PROGRAM VERIFICATION & SCHEMATIC DESIGN PHASES REPORT

SUNY OSWEGO GATEWAYS & EXTERIOR SIGNAGE

PROJECT NO. 10325A

MAY 3, 2013

Sweet Road South - Message Board Sign
Oblique Angle View

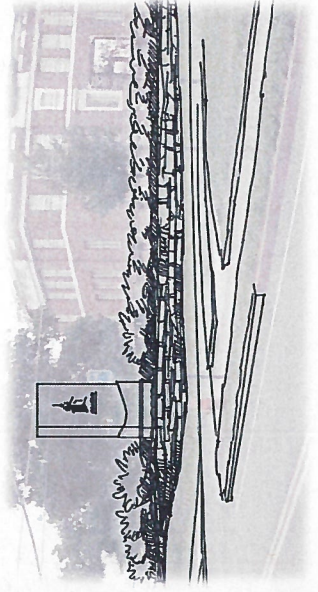
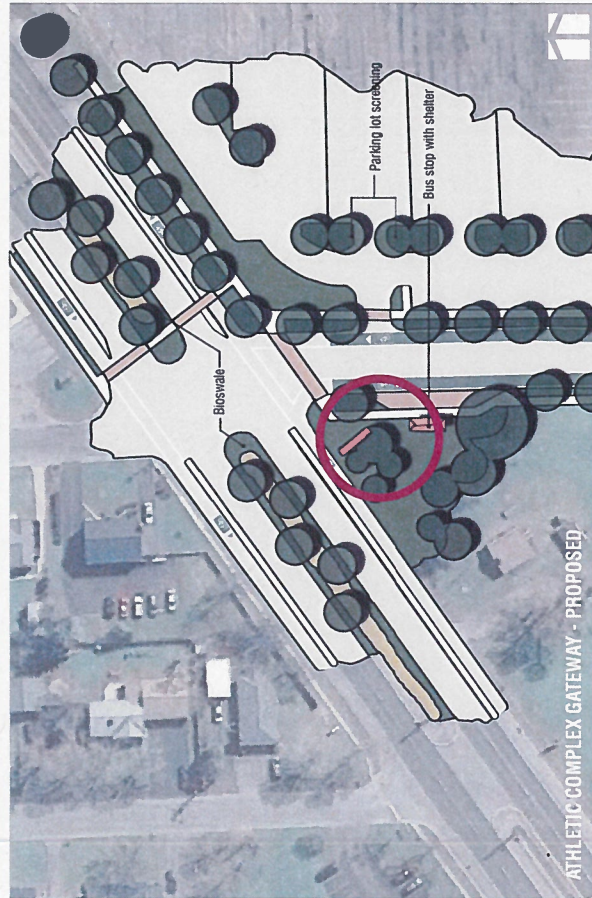
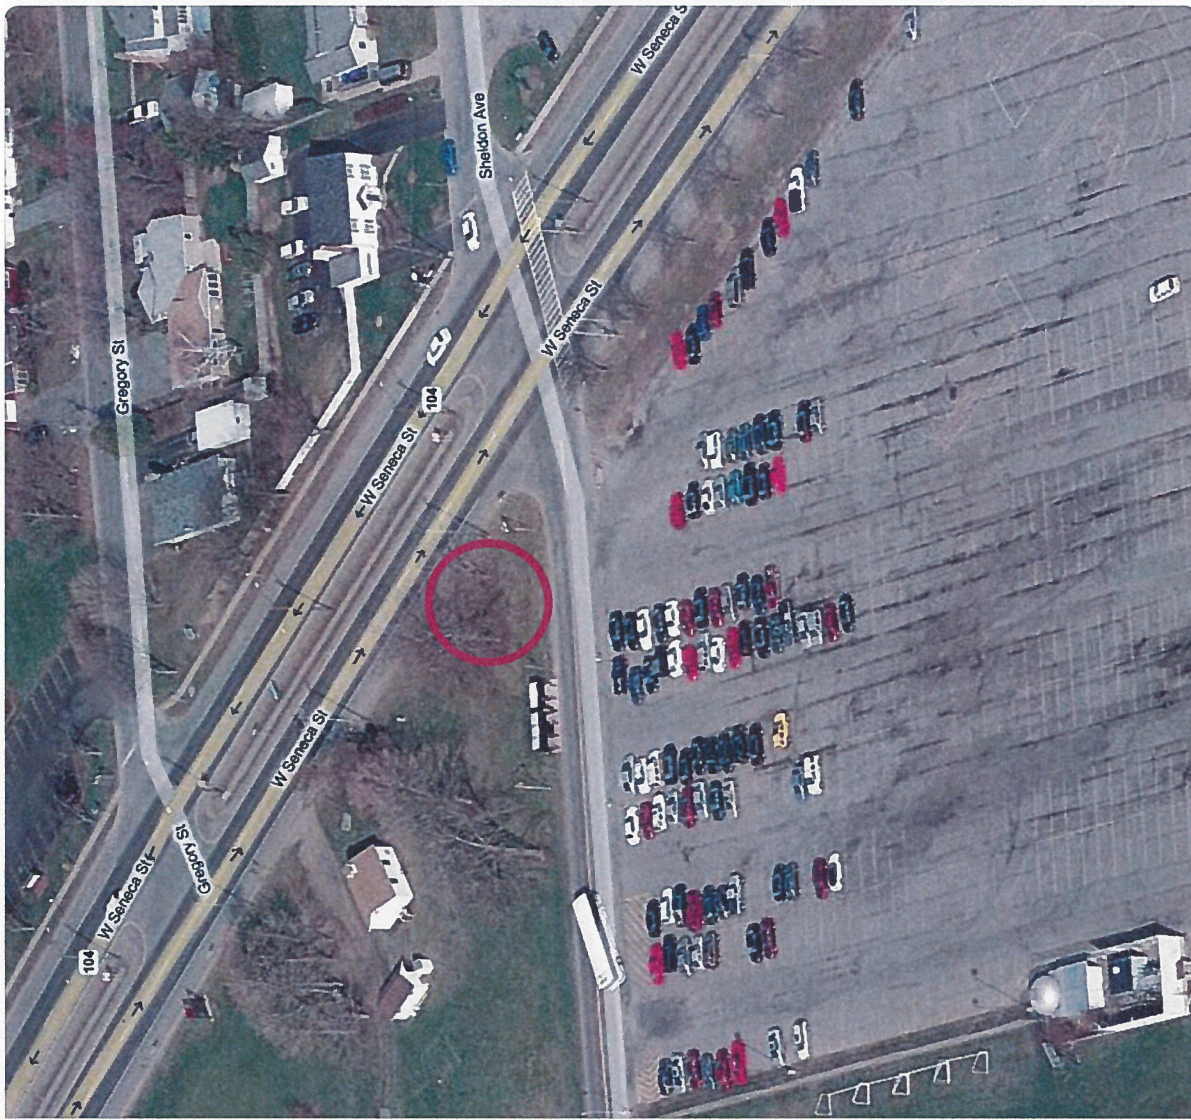
- We will return samples but need complete material sample submission as part of DM submission.
 - Revised Main 104 Gateway with both sides approved. LED panel on south side positive feedback. Request 2 lines of text (smaller) as Tom mentioned.

2. edr to research the LED message sign proposed for the Sweet Road South sign to see if there is an option to provide 2 lines of text. If there is, edr will update the "oblique angle view" graphic to show it.
